**In Response to CURE Requests 1-143
Application for Certification (08-AFC-5)
SES Solar Two, LLC**

08-AFC-5

Subject: SES Solar Two (08-AFC-5)
Responses to CURE Data Requests 1-143
URS Project No. 27657106.00400

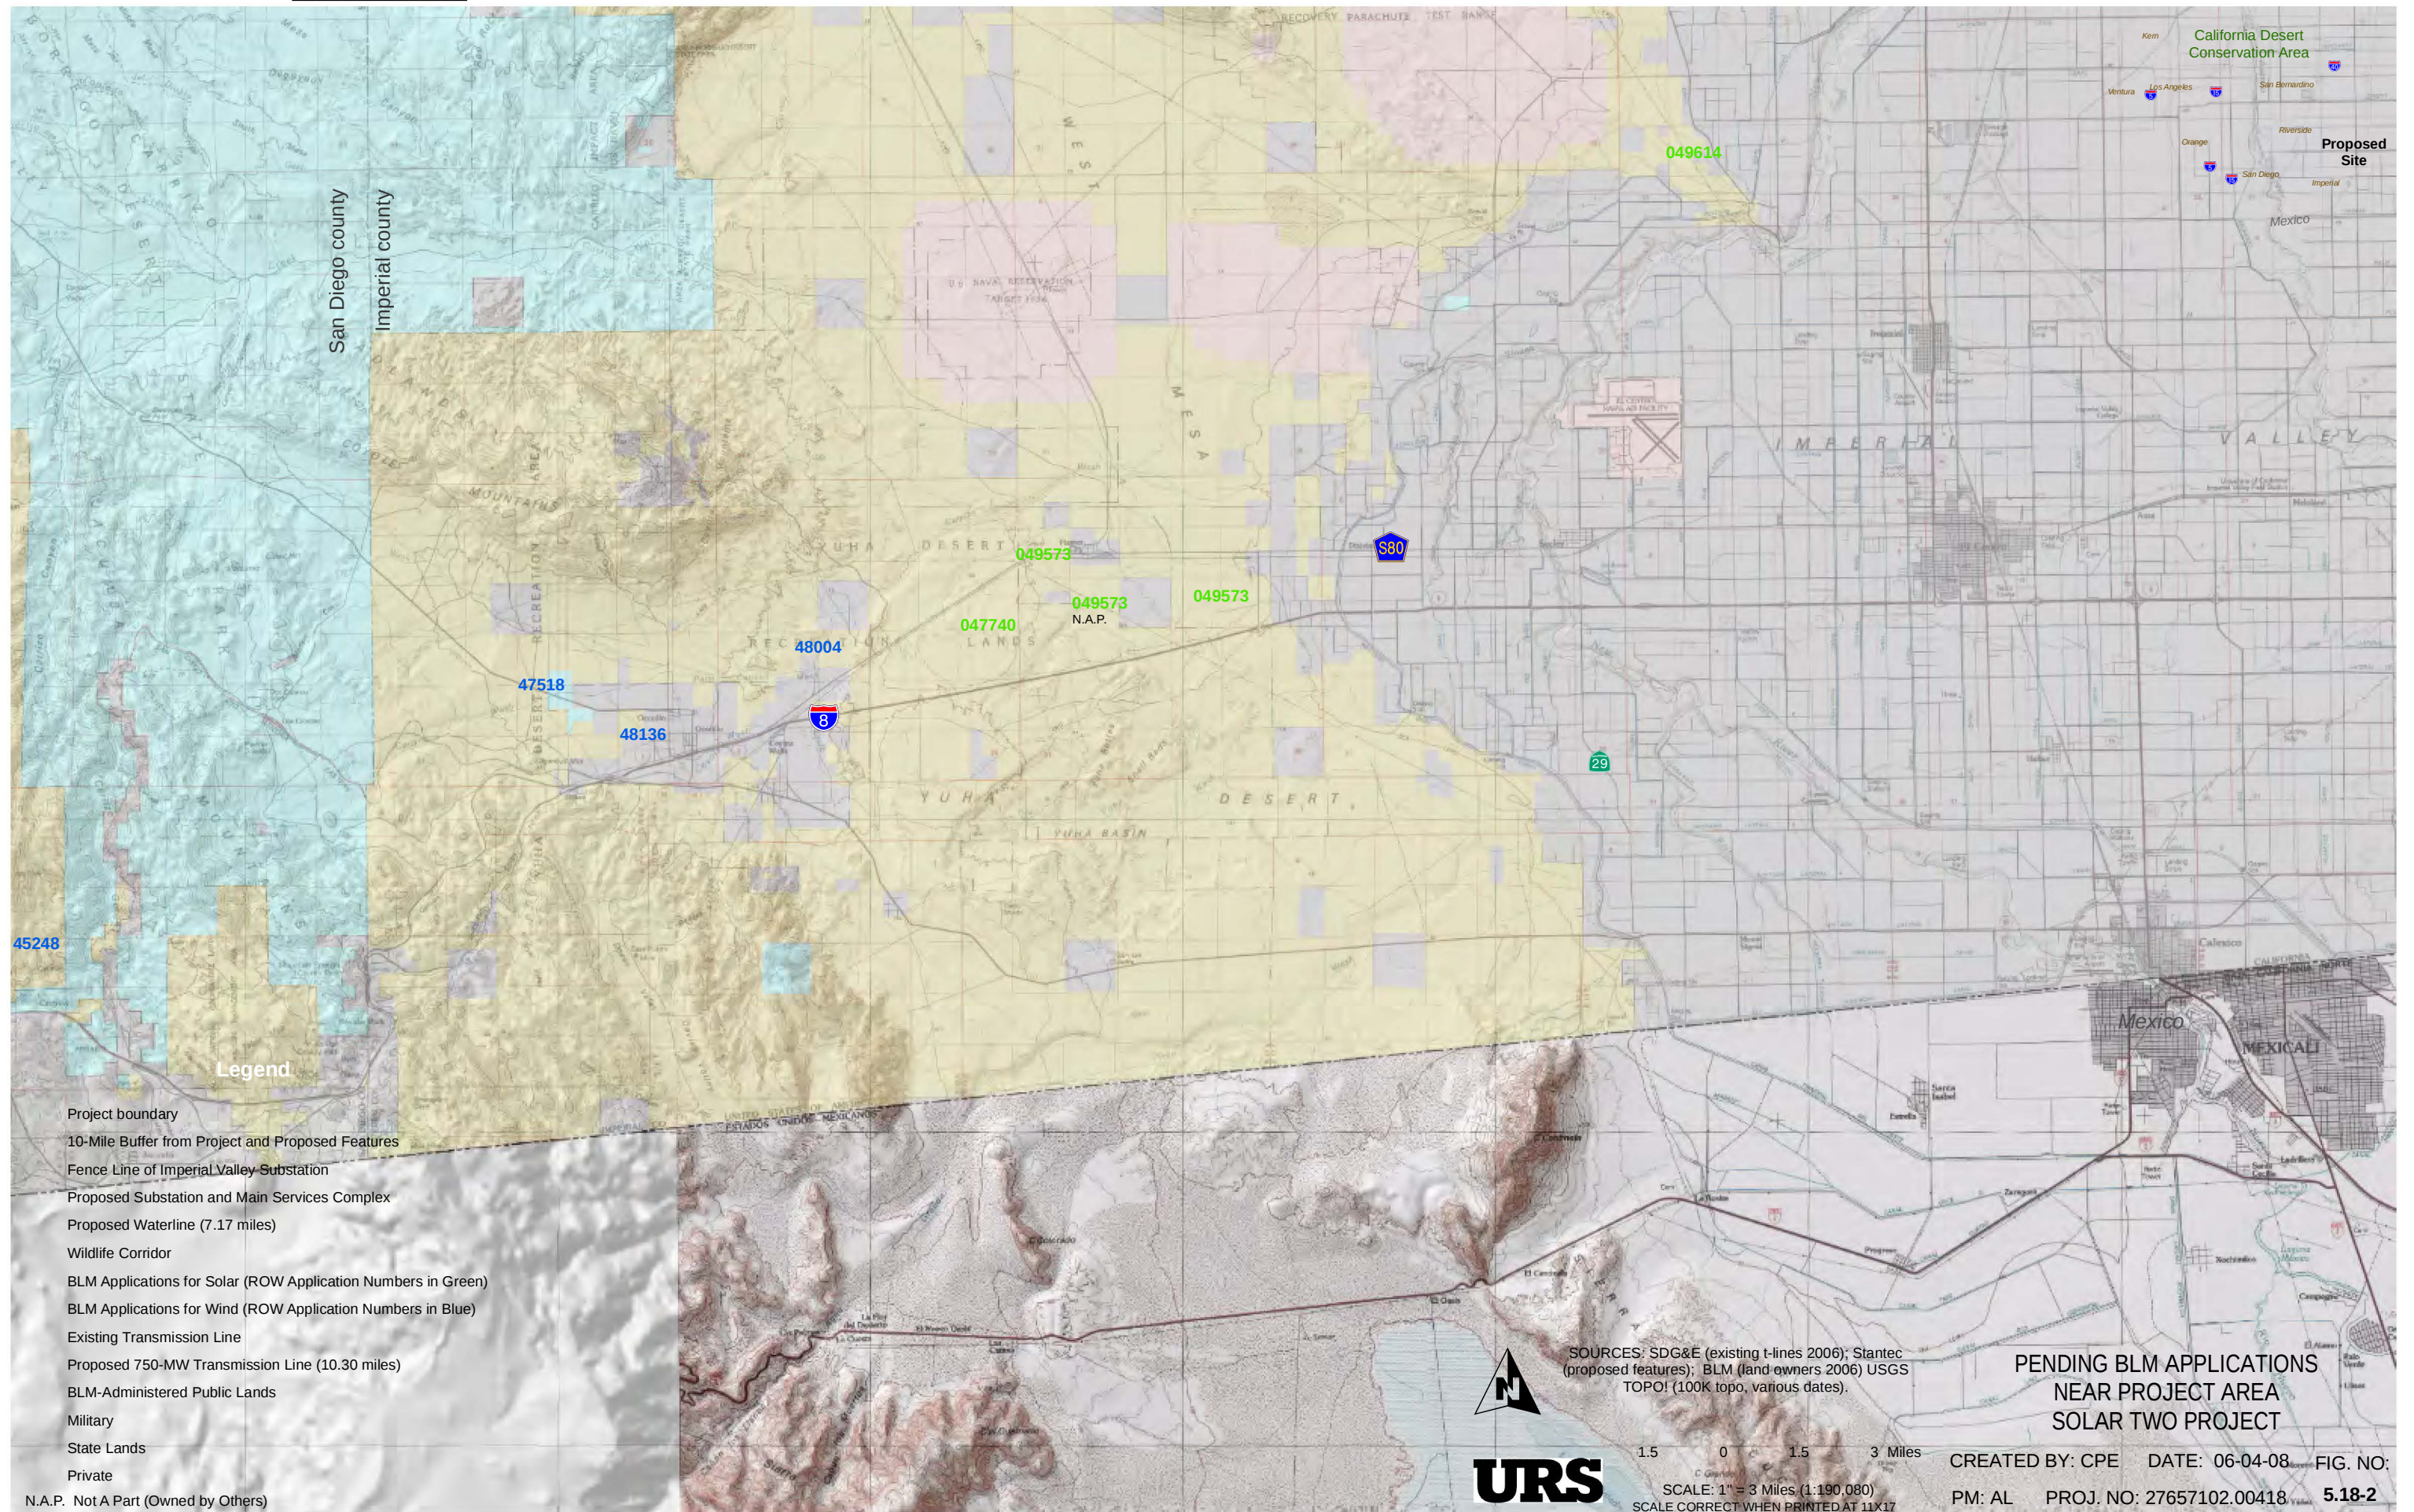
Data Request 42: Please provide an analysis of the Project's direct, indirect, and cumulative impacts on wildlife corridors.

Data Request 43: Please use the map provided in AFC Figure 5.18-2 to depict the “alternative routes” available to wildlife.

Response: The site is not considered an important wildlife corridor because it is bounded by I-8 to the south and S-80 (Evan Hewes Highway) and railroad tracks to the north and west. An area of open habitat will remain intact between the eastern Project boundary and Dunaway Road that could be used as a wildlife movement route. Additional opportunity for wildlife to move north or south of I-8 occurs west of the Project site (please see attachment BIO-1 provided behind this response).

Response: See attachment BIO-1, a figure with alternative routes for wildlife movement added to Figure 5.18-2 provided with the response to Data Request 42.
